REV.
E

AS5196™

RATIONALE

FITTING, ELBOW, 45°,
FLARED TO PIPE

FIGURE 2 - PORT #2 CONFIGURATION FOR SIZES 0202 AND 0203 ONLY /19/

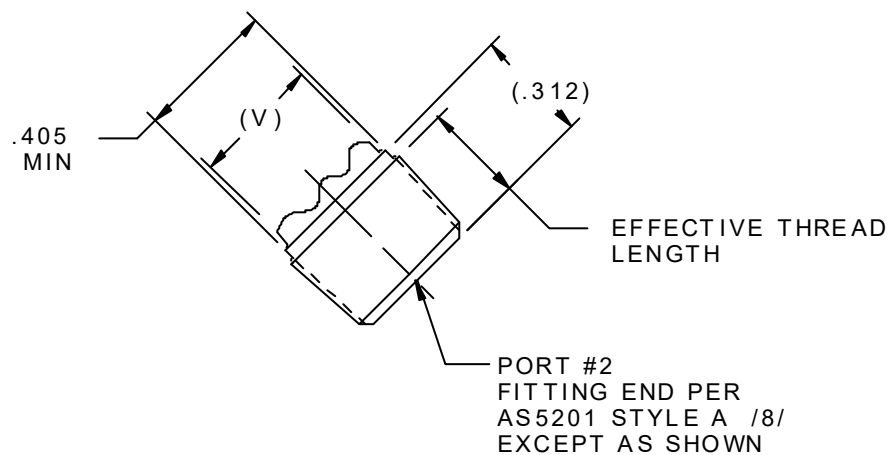
ADDED NEW NOTE /19/ AND FIGURE 2 TO REDUCE DIAMETER B OF AS5201 FOR SIZES 0202 AND 0302 ONLY AND FACILITATE ANPT THREAD GAGE INSPECTION.
